**RE: Bosque Plaza – Guardian Storage
Conceptual Grading and Drainage Plan
Stamp Date: 10/20/17
Hydrology File: E12D006E**

Based upon the information provided in your submittal received 10/20/2017, the Conceptual Grading and Drainage Plan **is not** approved for Site Plan for Building Permit. The following comments need to be addressed for approval of the above referenced project:

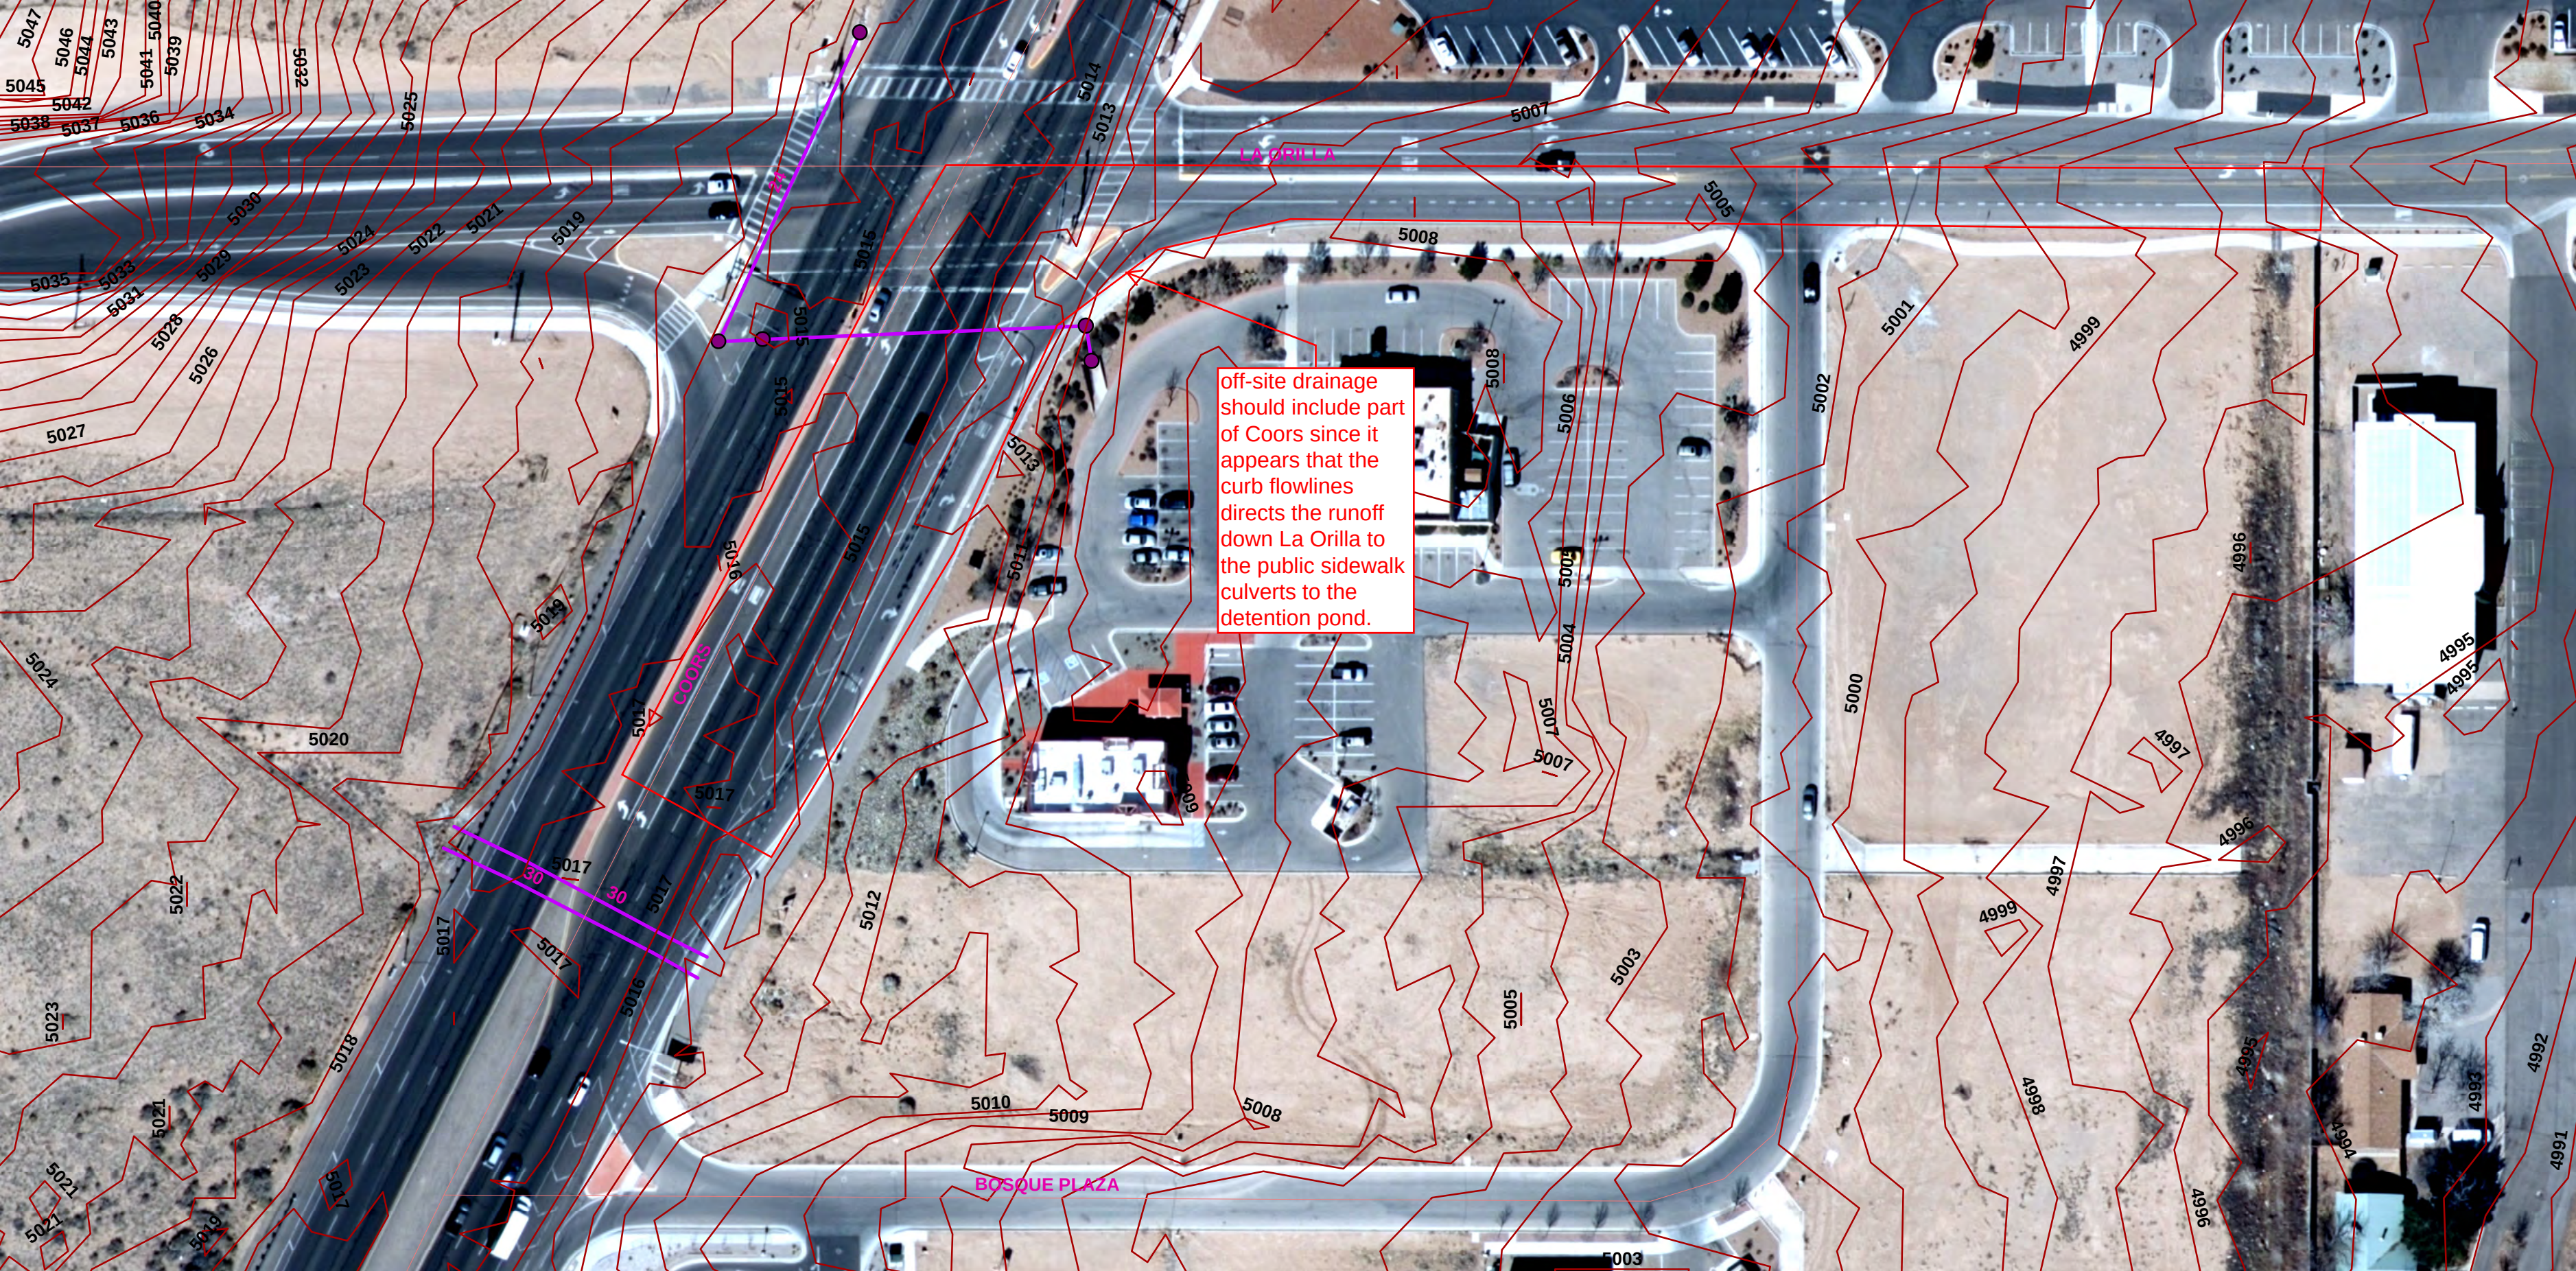
1. See attached aerial with contours from the City's GIS. It appears that the off-site area draining into the existing sidewalk culverts on La Orilla picks up some drainage from Coors as well. Please review and correct drainage area for Basin ID 101.

off-site drainage
should include part
of Coors since it
appears that the
curb flowlines
directs the runoff
down La Orilla to
the public sidewalk
culverts to the
detention pond.
